03-318559
PERMIT
SEWAGE DISPOSAL SYSTEM

HOWARD COUNTY HEALTH DEPARTMENT
BUREAU OF ENVIRONMENTAL HEALTH

ADDRESS 2858 Flag Marsh Road Mt. Airy, MD 21771 PHONE 795-8691
SUBDIVISION Thompson Property LOT Parcel 1 ROAD 11872 Thompson Drive
PROPERTY OWNER Robert Steves

SITE PLAN
REVISED PARCEL 1
MURLE THOMPSON PROPERTY

INDICATE NORTH - NAME ADJOINING ROADWAY AS BASE LINE
THOMPSON DRIVE

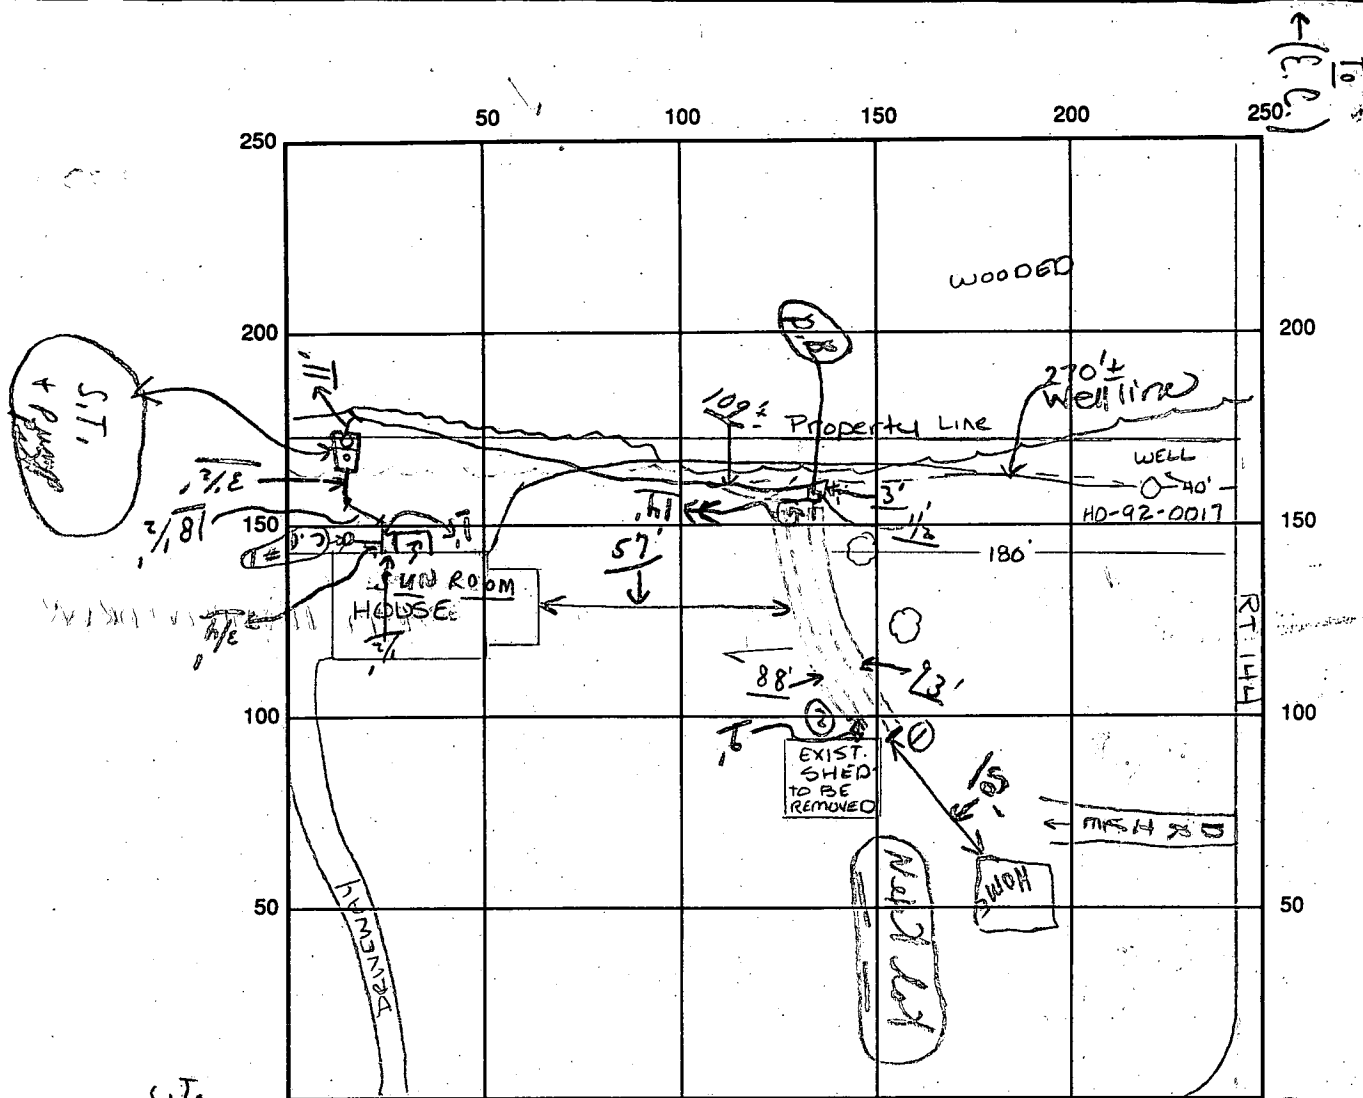
REMARKS: 1-11-95: START FIRST TRENCH 180 FEET FROM MD RT. 144 (BELOW 2 LARGE TREES) - THIS IS TO ACCOMMODATE 10' SEPERATION FROM SEPTIC TO WELL LINE. PLACING IN SHORTER TRENCHES AT THE HIGH END WOULD USE UP TOO MUCH OF THE SDA-2 REPAIRS WOULD NOT FIT. FUTURE REPAIRS WILL BE AT THE HIGH END OF THE FIELD - 100' WELL TO SEPTIC SEPERATION WILL NOT BE NECESSARY WHEN PUBLIC WATER COMES IN 1 YEAR. AWW

1-18-95 Partial - ① need pumps started before final approval; no electricity; ② no. 1 to see dist. box, area inside @ time pumps tested - final except ① & ② above; partial cse

1/16 WAIT FOR A CALL FOR FINAL; SEE ABOVE "cse" Note
P.M. 3/15/95 Pumps & controls in basement tested - OK Final cse 3/15 electricity lines on top of ground. cse

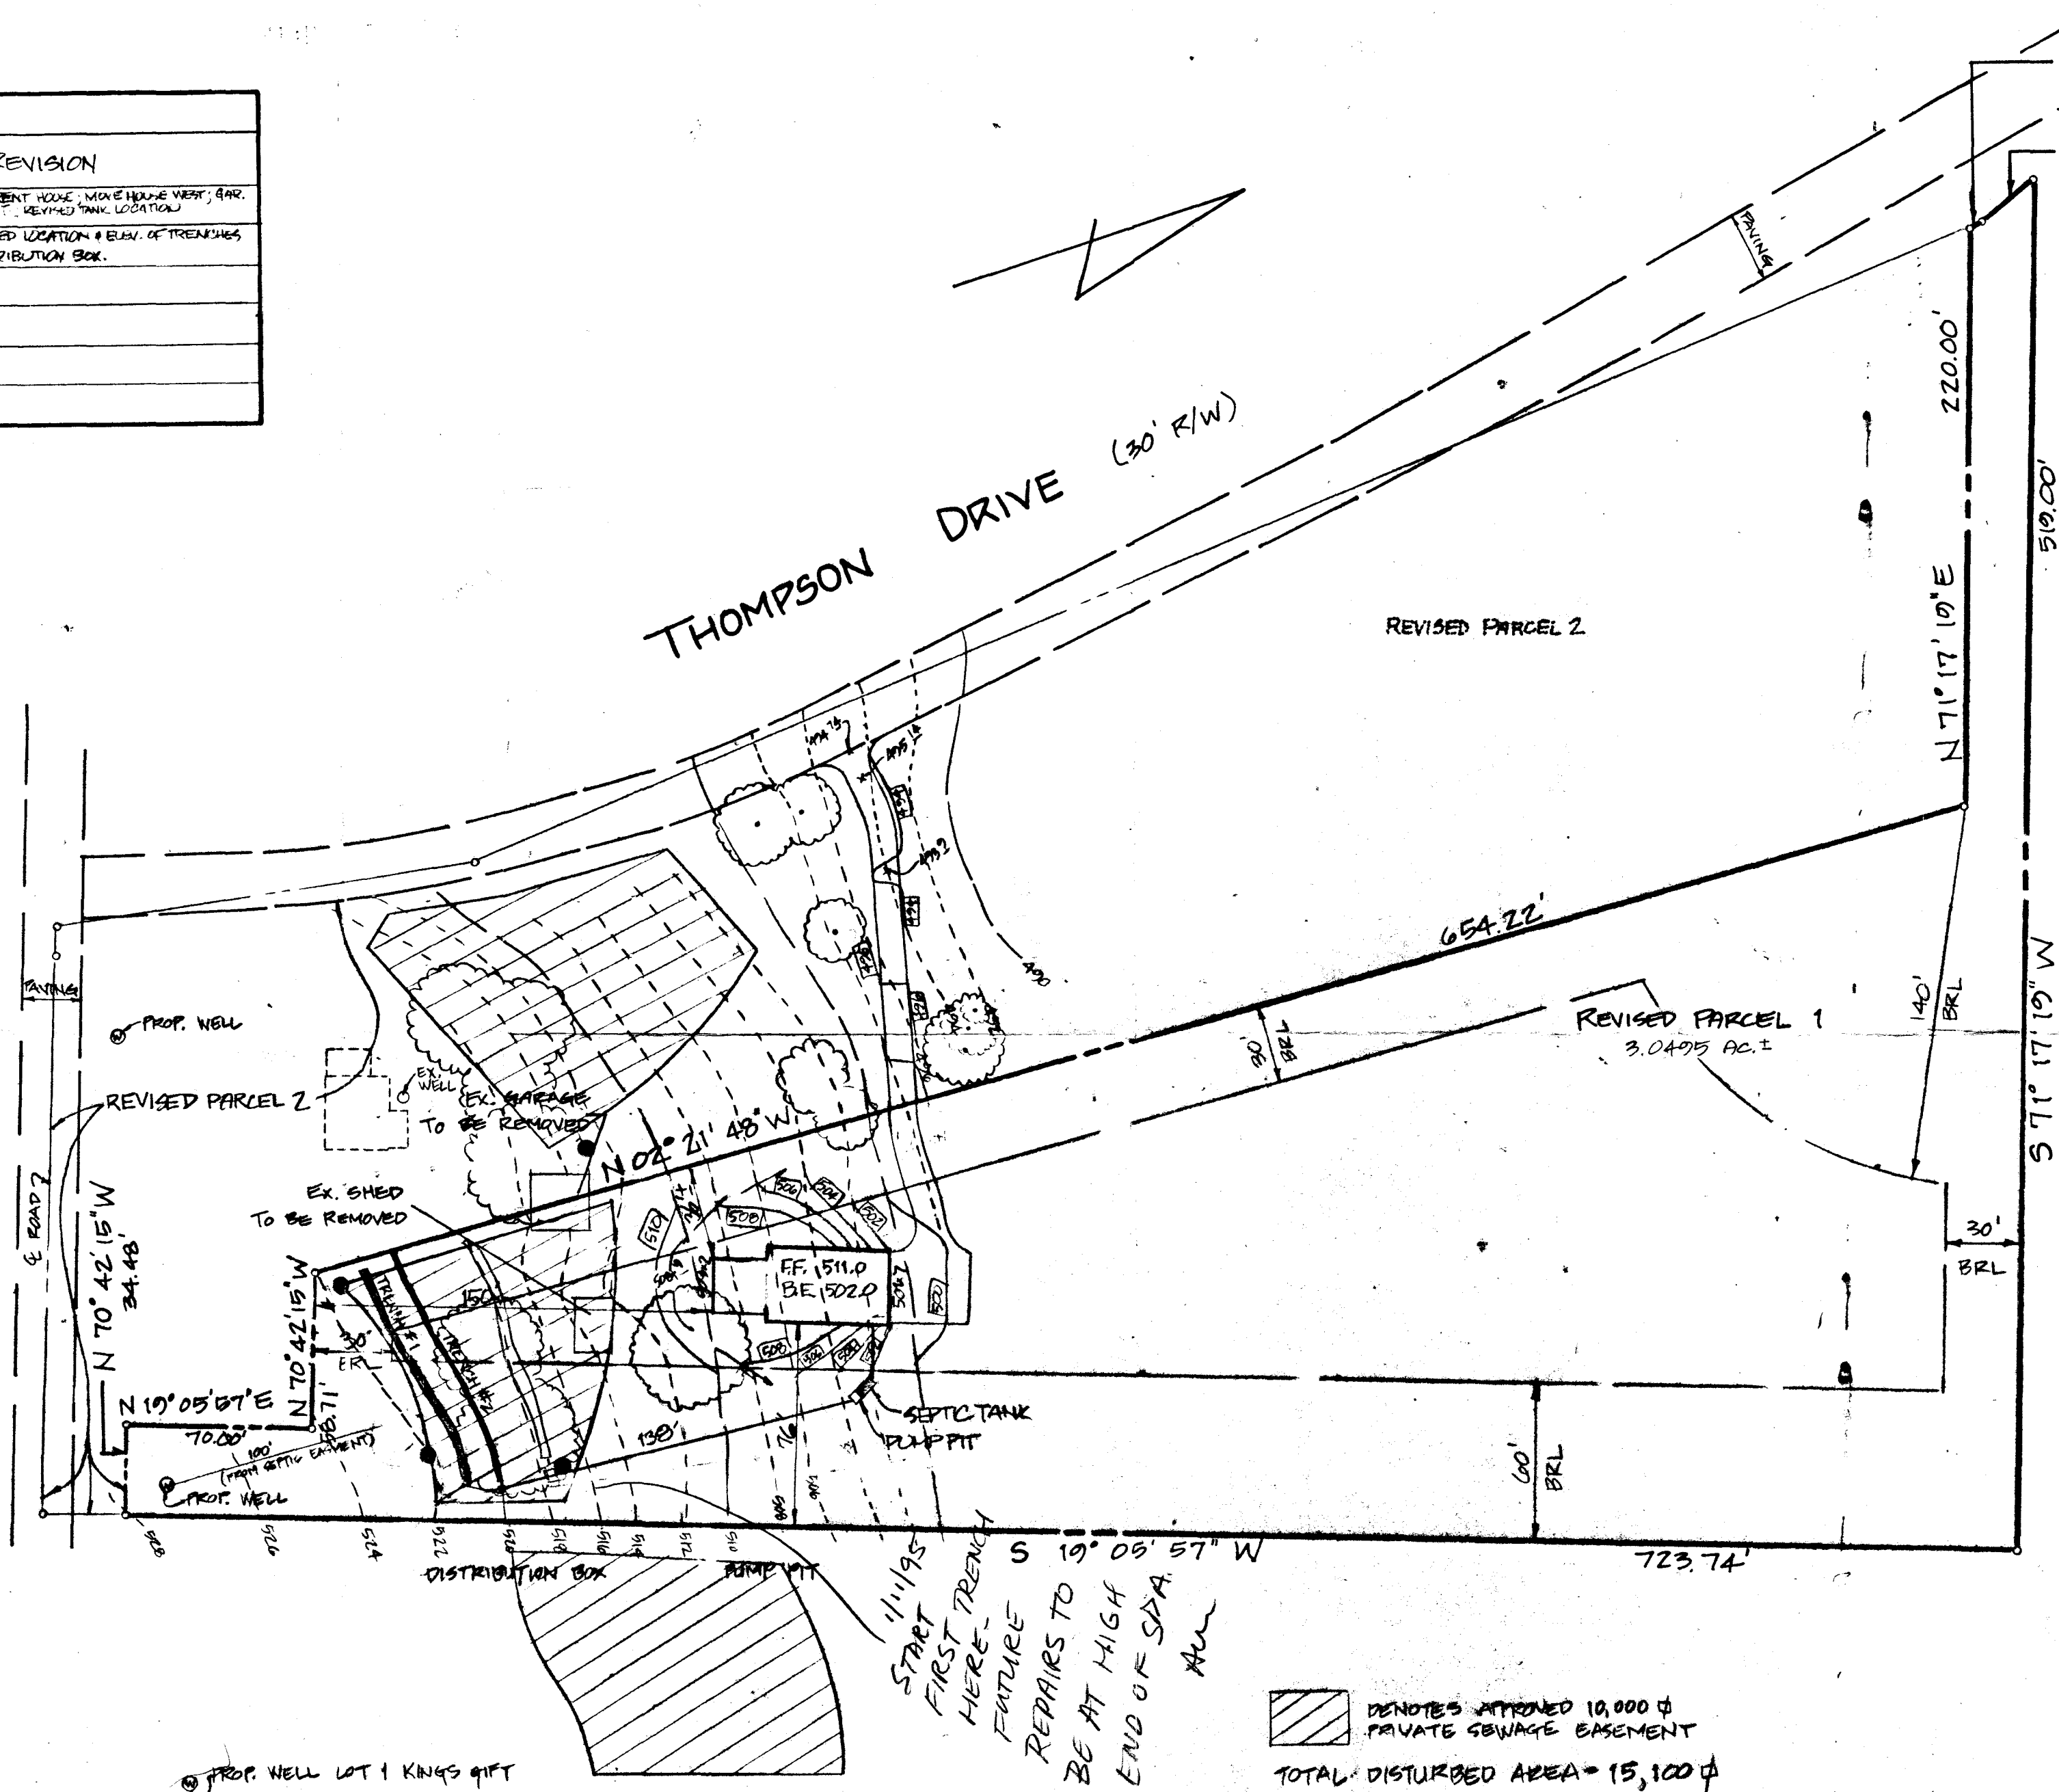
REVISIONS				
REV. NO.	DATE	REVISION REQUESTED BY	REVISION MADE BY	REVISION
1	7/14/94	SUNSET HOMES	S&L	DIFFERENT HOUSE, MOVE HOUSE WEST, GAR. IN BACK, REVISED TANK LOCATION
2	8/9/94	HEALTH DEPT	S&L	CHANGED LOCATION & ELAV. OF TRENCHES & DISTRIBUTION BOX.
